10.12.14 MODIFICATION TO DA NO 263/14

**PROPOSED ALTERATIONS AND ADDITIONS**  
**WISEMAN RESIDENCE 63 MARINE PARADE AVALON**  
 MAY 2014 DWG 0514 - 1/5 SHIMDESIGN design and drafting 0400 898 744

**PROPOSED ALTERATIONS AND ADDITIONS**  
**WISEMAN RESIDENCE 63 MARINE PARADE AVALON BEACH**  
 MARCH 2019 DWG 0319 - 4/5 SHIMDESIGN design and drafting 0400 898 744

SITE PLAN 1:200

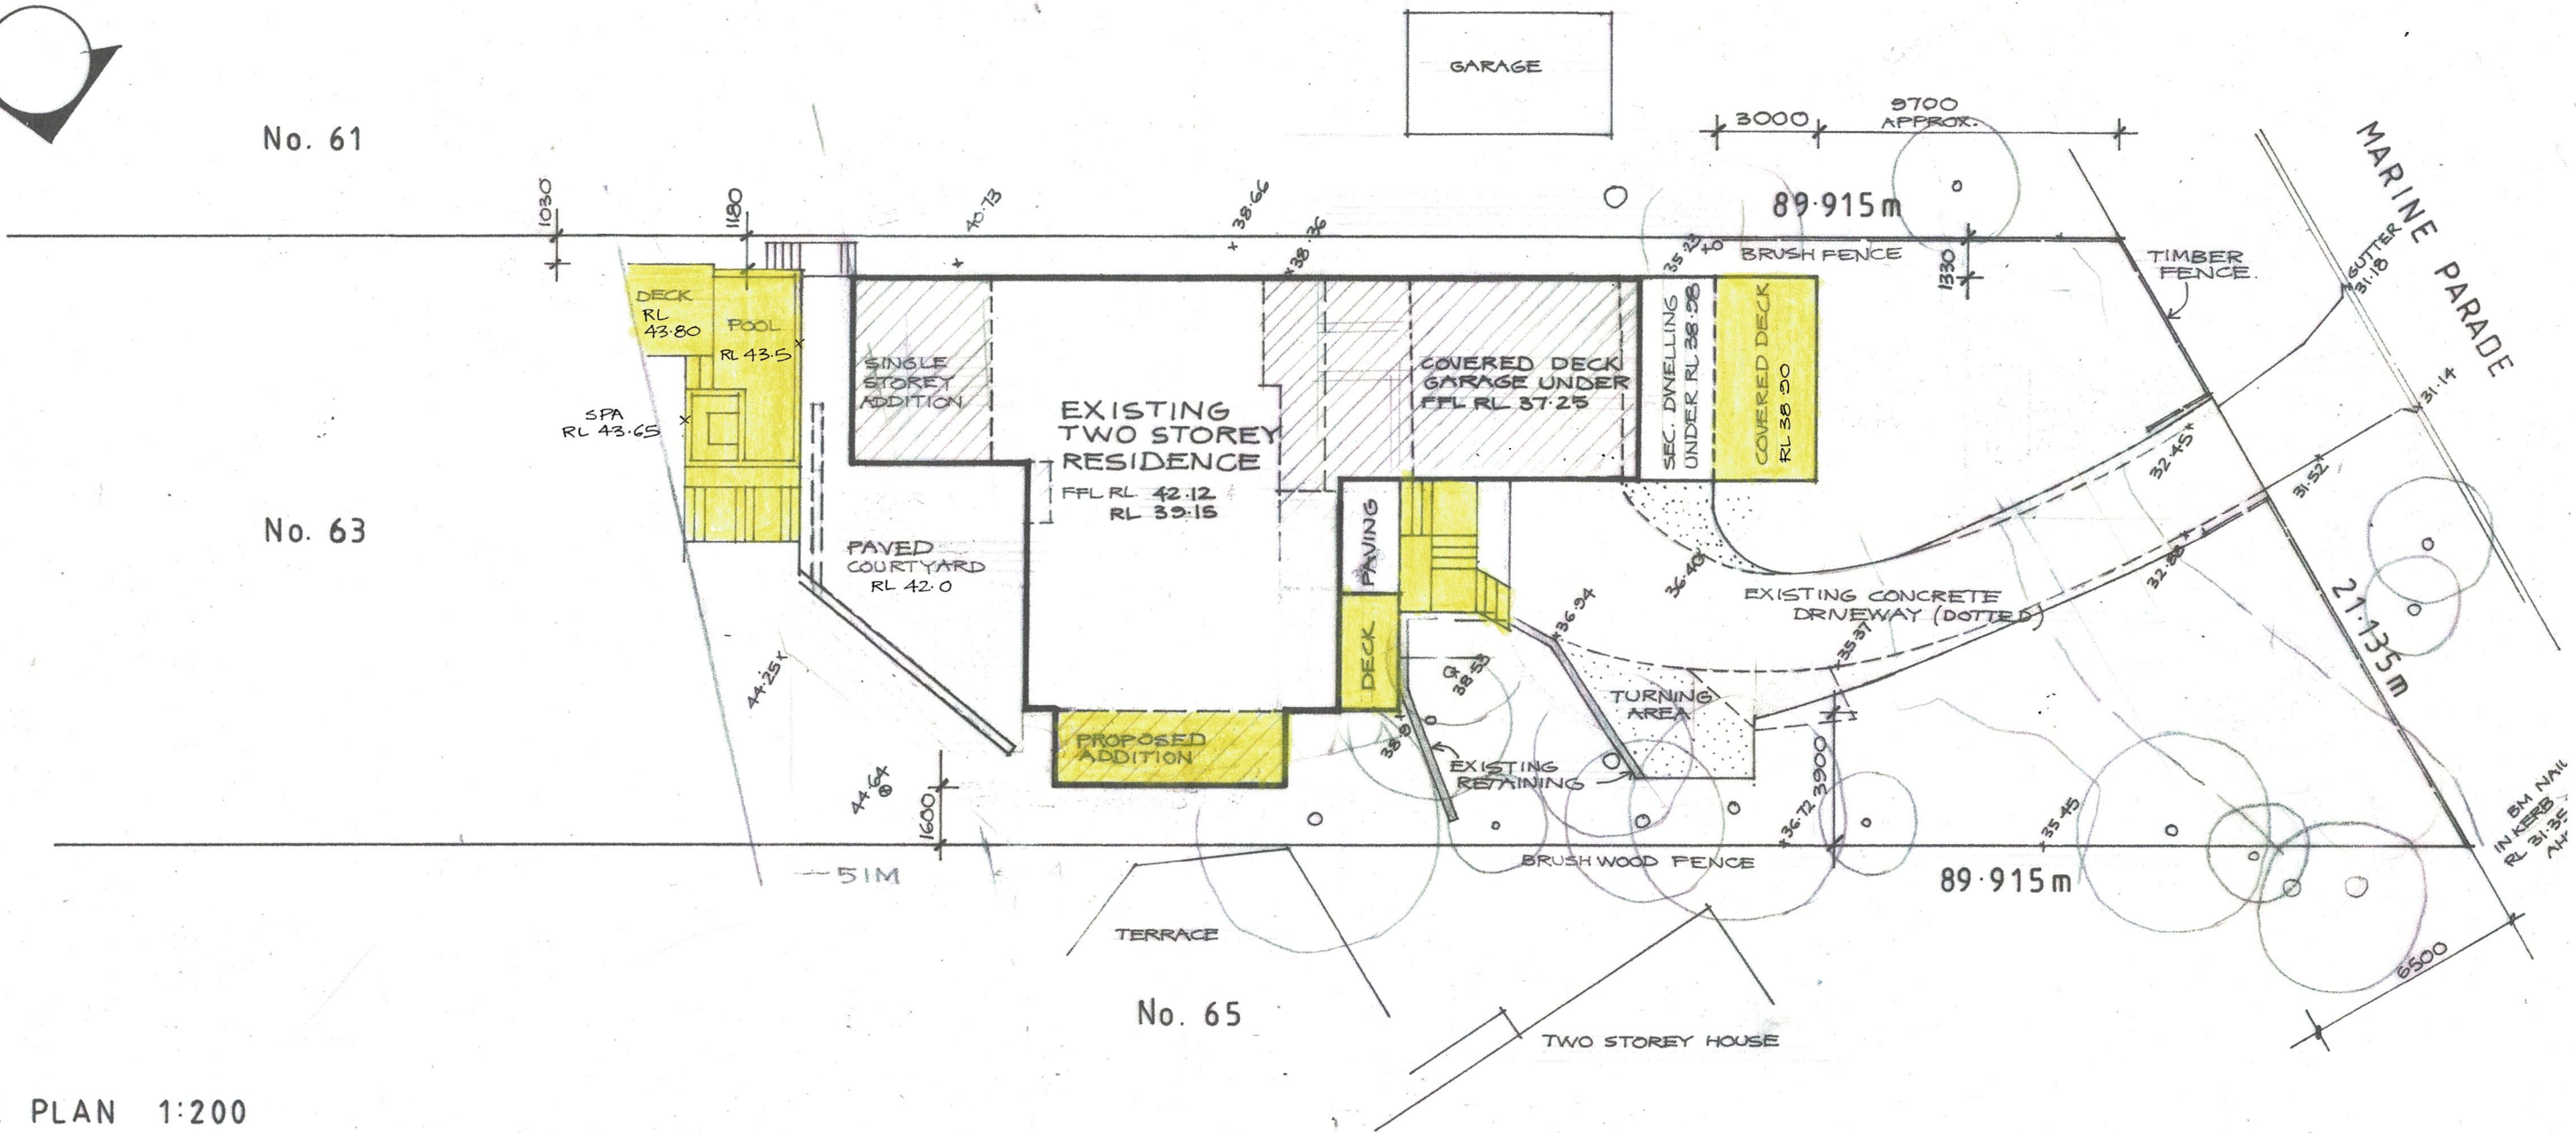
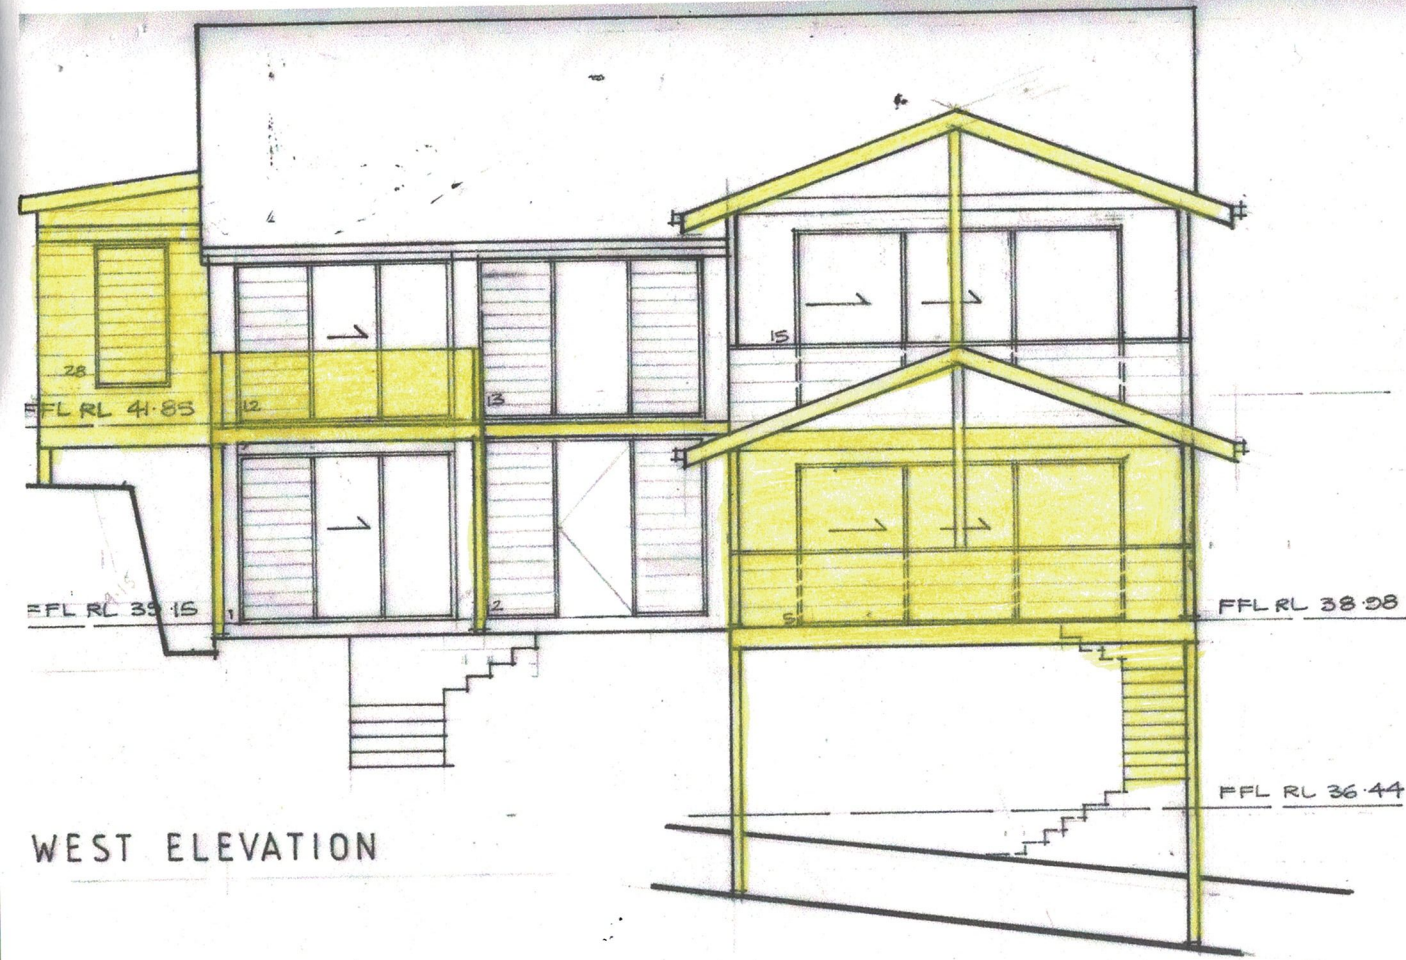
24.11.14 REDUCE ROOF TO DECK / DELETE CABANA, ROOF PERGOLA IN LIEU.
